Request for Non-Material Change - CD Project 5.11 - Installation of a 60-Inch Force Main from

Kendall Drive to PS 0536

То	Daniel J. Edwards, PE		
CC	David Haywood, PE, Maricela Fuentes, PE, Franklin A. Torrealba, PE		
Subject	CD PROJECT # 5.11, PCTS: 13149 Installation of a 60-Inch Force Main from Kendall Drive to PS 0536		
From	Guillermo Regalado, PE / Consent Decree PMCM Team		
Date	August 7, 2015		
Page	16

Technical Memorandum

Figure 8: Proposed Alignment for Route 1

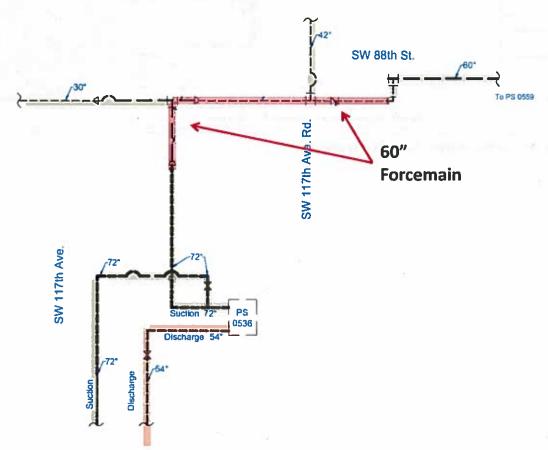
As presented in Figure 8, the proposed 60-inch force main connects to an existing 72-inch prestressed concrete cylinder pipe (PCCP) along SW 117th Avenue, approximately 60 LF south of SW 88th Street (Kendall Drive). The proposed project has 60-inch tee and a 60-inch x 30-inch reducer at SW 88th Street to provide connections to the 30-inch ductile iron (DI) force main to the west and to the proposed 60-inch force main to the east. The proposed 60-inch force main then connects to an existing 60-inch PCCP force main located approximately 100 LF east of the SW 117th Avenue/Road and SW 88th Street (Kendall Drive) intersection.

Figure 11: Proposed Alignment for Route 4

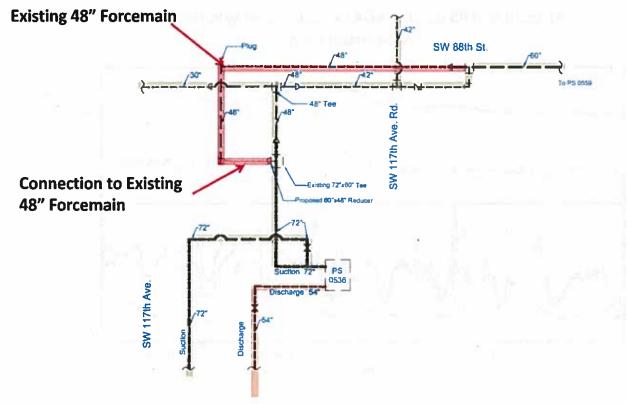
As mentioned earlier in this document, there is an existing 48-inch line that is not connected to the suction side of PS 0536. This line can be utilized to improve the conveyance of flow between the two pump stations. This route involves the connection of the existing 48-inch line to the suction side of PS 0536. As presented in Figure 11, the proposed 48-inch connection begins approximately 100 LF south of the centerline of SW 88th Street on SW 117th Avenue, and connects to the existing 72-inch PCCP force main with a 48-inch PCCP force main (approximately 110 LF long). The west connection between the new 48-inch and the existing 48-inch PCCP force main is done with a 36-inch tapping sleeve to avoid size on size tapping that would compromise the structural integrity of the existing pipe.

The CD PMCM Team recommends moving forward with the 48-inch connection to the suction side of PS 0536, instead of the 60-inch force main initially planned along Kendall Drive.
